US Highway 14 Streetscape Workgroup

Meeting Notice and Agenda

Village of Cross Plains

WILSON STREET - CROSSING #7

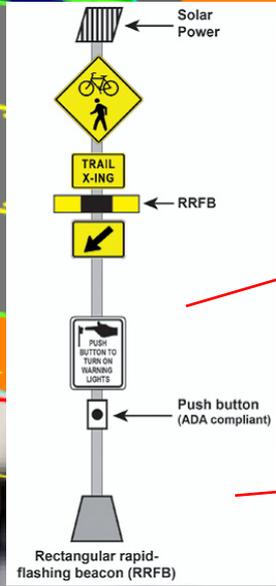
The only change was that the permit required the northern RRFB be moved from the west crosswalk to the east. Push buttons are available at all crossings.

CAESAR STREET - CROSSING #10

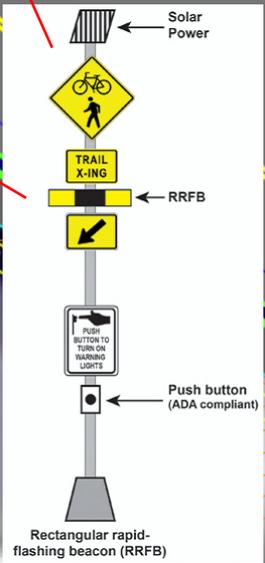
Two Changes: 1) both poles will be on the west side of the crossing instead of staggered; and 2) the poles will support an overhead banner.

Production Print

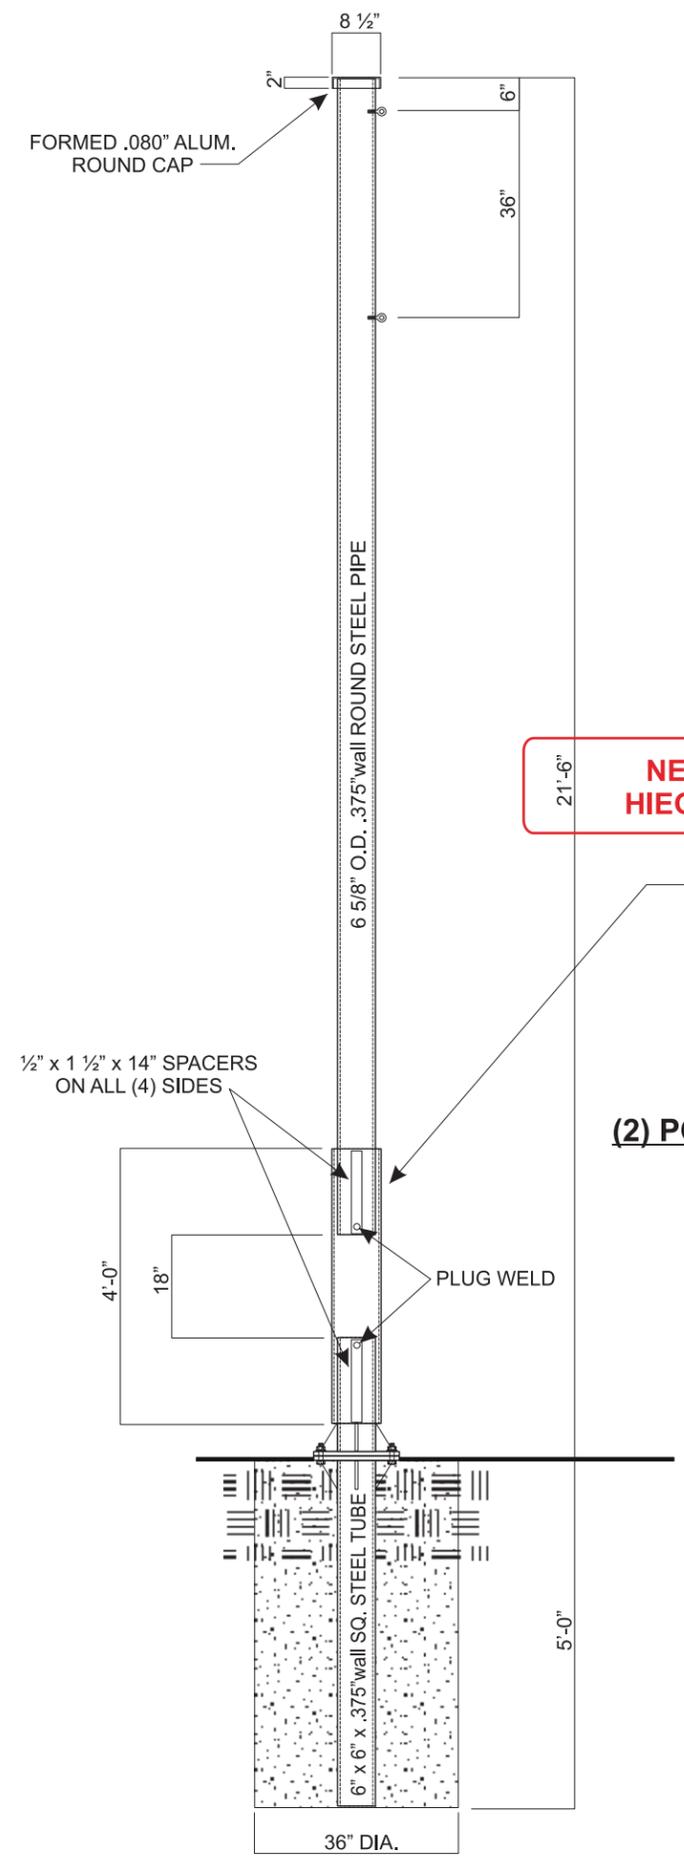
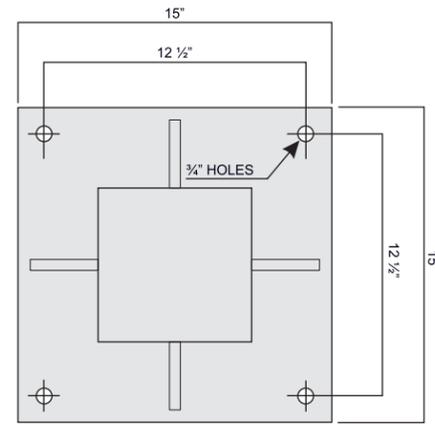
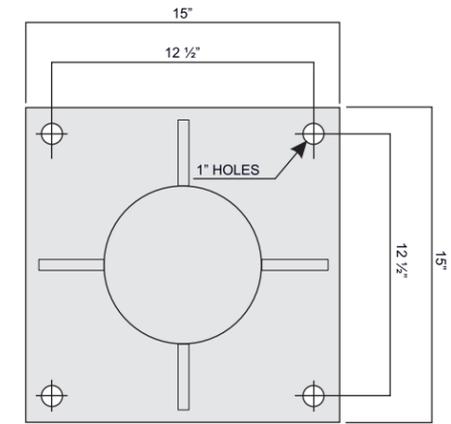
NEW HEIGHT
21'-6"

8 5/8" O.D. ROUND STEEL PIPE .25" wall SLEEVE ADDED TO EXISTING POLE / CUT EXISTING PIPE OFF 15" ABOVE GUSSETS / RAISE PIPE 18" AND WELD IN SLEEVE
